Staff Summary Report

City Council Meeting Date: 01/08/04 Agenda Item Number: 56

SUBJECT: Request by Patrick Panetta, representing Arizona State University, to appeal the

conditions of a Redevelopment Review Commission approval (RRC 03049) for a sign request for Arizona State University, Institute for Computing & Information Sciences &

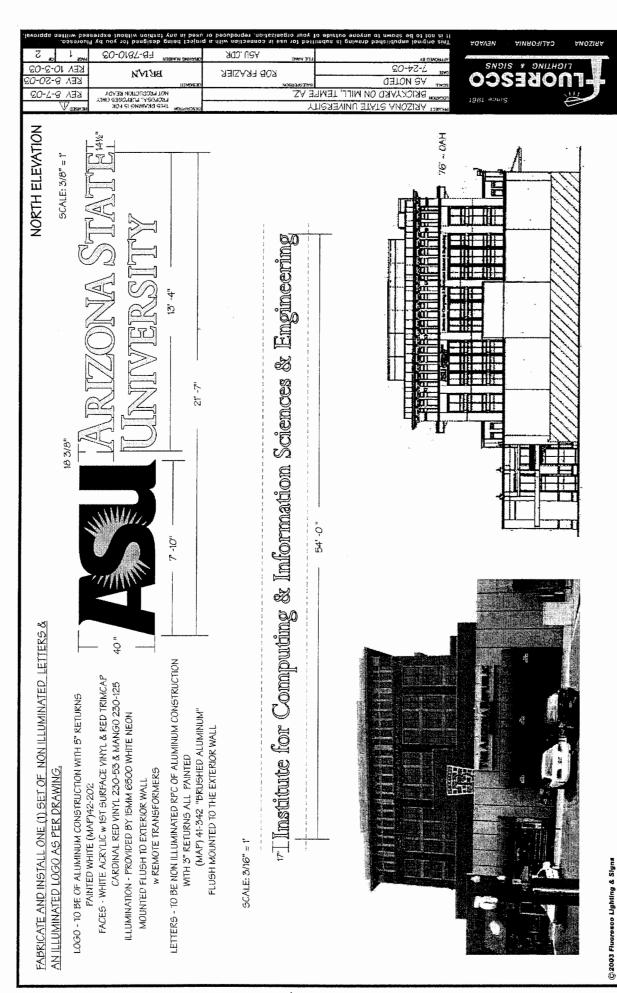
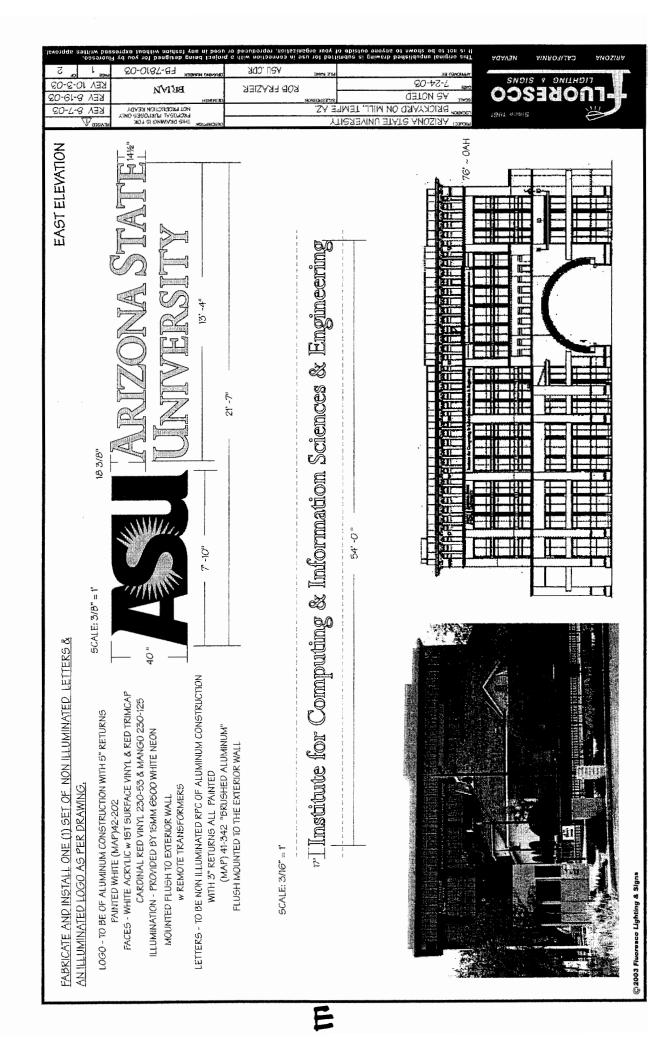
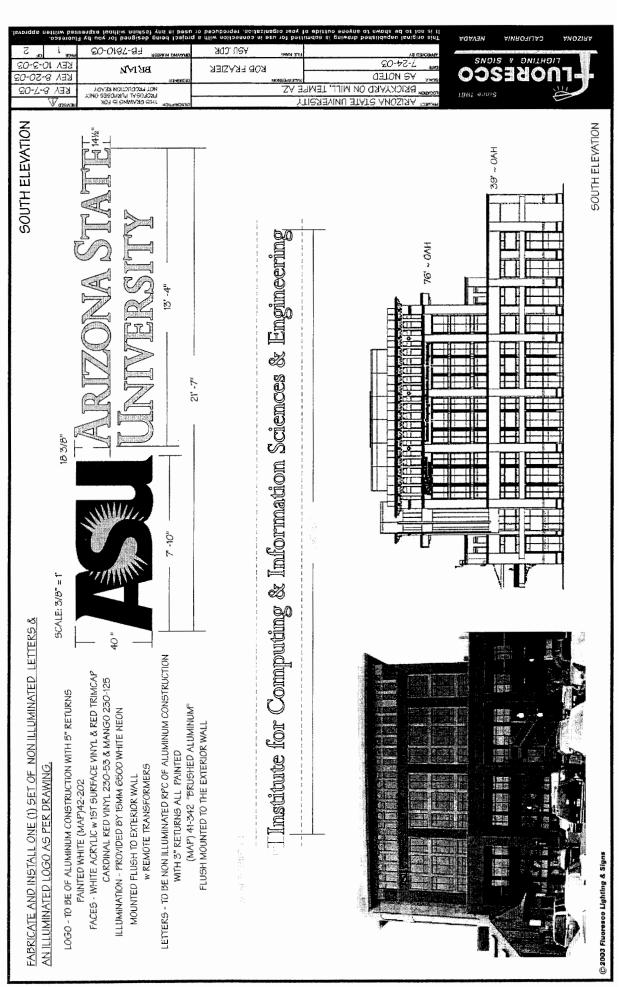
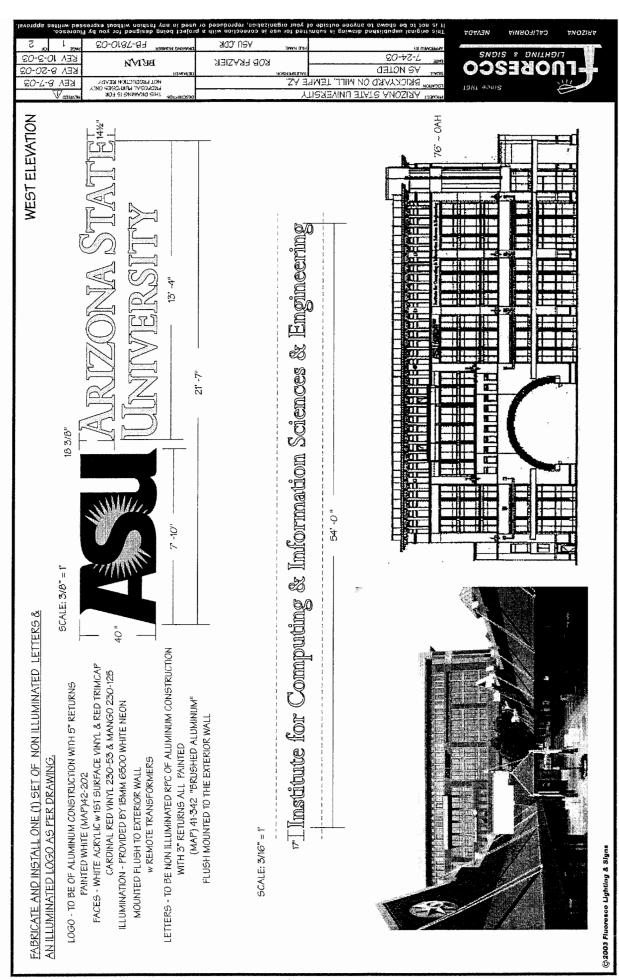
Condition number 4, **modified** to read. Delete "ARIZONA STATE UNIVERSITY – Institute for Computing & Information Sciences & Engineering" from the north, west and south facades of the Brickyard building. ASU logo to remain. Meet with Staff to coordinate exact location of logo.

Condition number 5, **added** to read. Delete "ARIZONA STATE UNIVERSITY" from the east facade of the Brickyard building. ASU logo and "Institute for Computing & Information Sciences & Engineering" to remain. Meet with Staff to coordinate exact location of logo.

As noted in the attached plans, all of the proposed signs on the Brickyard building are located in *Zone 1A*. This is the designated zone that will house building mounted signs between the 5th and 6th floors of the structure on the north, south, east and west elevations. Designated sign locations within this zone are defined by the rectangular brick envelopes that are divided by the building's column elements. This zone provides four (4) possible sign locations on both of the east and west building elevations, while three (3) locations are possible on each of the north and south elevations. Of the fourteen (14) possible locations, only four (4) may be occupied by signage. The new tenant, ASU, is proposing to utilize twelve (12) of the fourteen (14) sign envelope locations. Staff would also like to point out

that the package criteria restricts all signs in *Zone 1A* to non-illuminated metal letters. The "ASU" logo for proposed sign (a) does not conform to this criteria.

- 1. All City Council conditions of approval shall be adhered to prior to the variance becoming effective.
- 2. The variance is not transferable. Variance is valid for ASU only.
- 3. Obtain sign permits prior to installing new signs.
- 4. Delete all proposed signs on the east and west elevations of the Brickyard building.
- 5. No exposed conduit allowed for any signs.
